| PROJECT NAME: BASIC 200 | | | Description: BASIC-200 PRE AMP+ POWER SUPPLY | | | | |
| PCB: | Sheet: | Revision: | DEL 30/08/04 REV1_2 | Note: | | | |

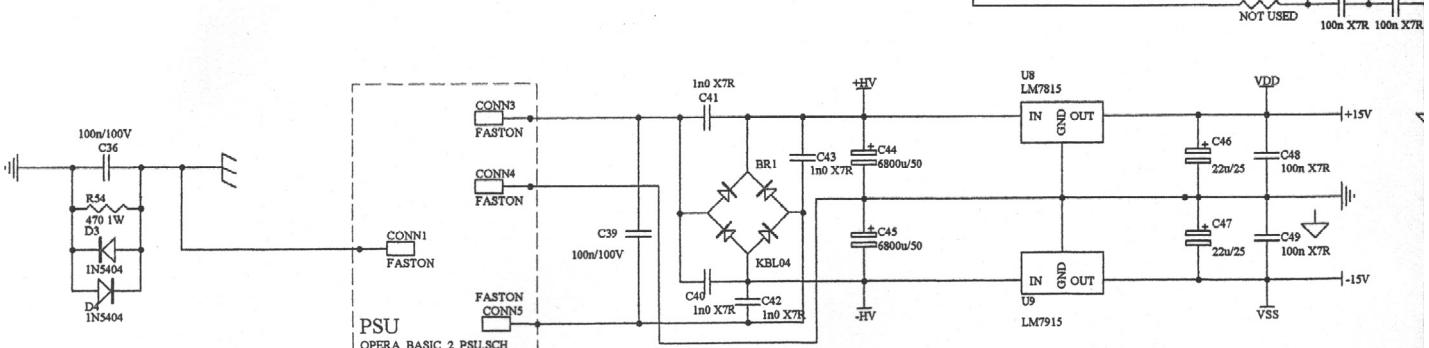
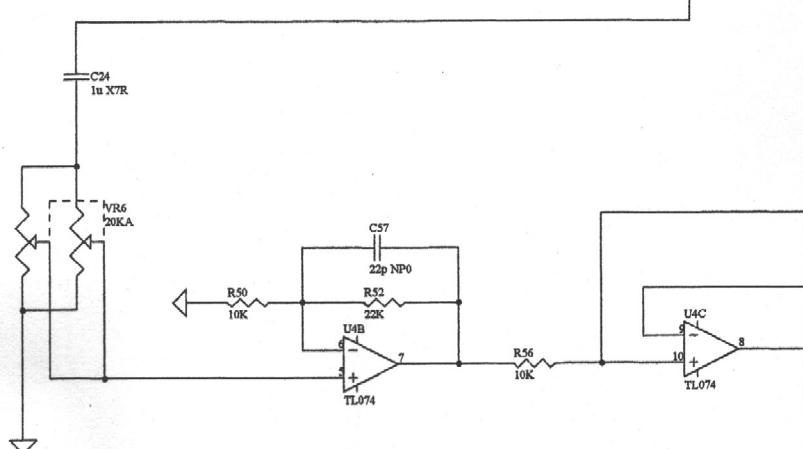
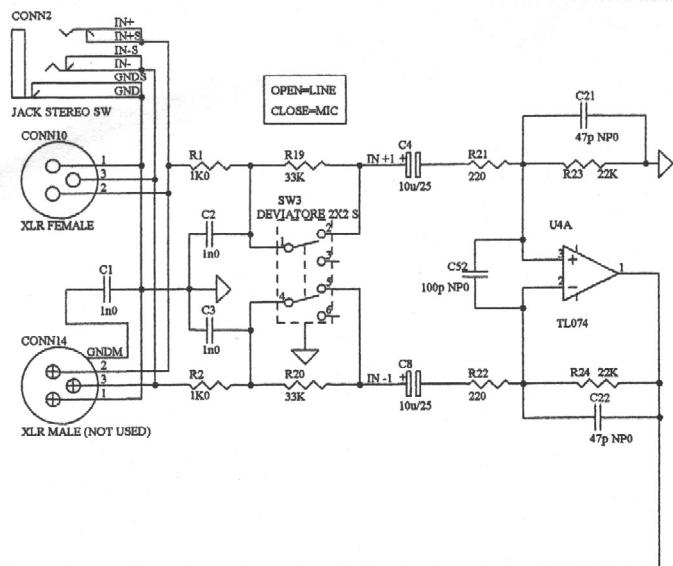
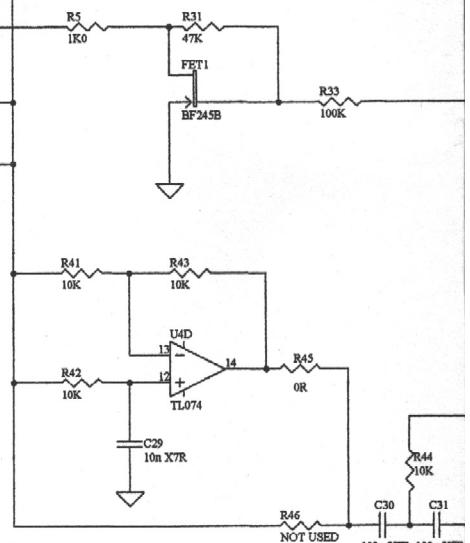
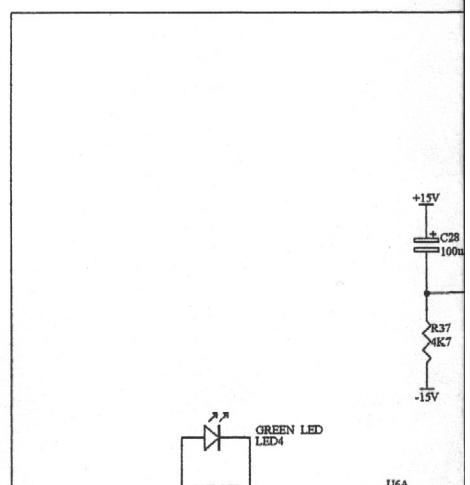
| PROJECT NAME: BASIC 200 | | | Description: BASIC-200 PRE AMP+ POWER SUPPLY | | | | |
|------------------------------------|--------|-----------|---|---|--|--|--|
| PST366C | 1/1 | | | 30/08/04: CHANGED R27 (GAIN TW) FROM 56K TO 68K CHANGED U5 FROM TL074 TO NJM2060 | | | |
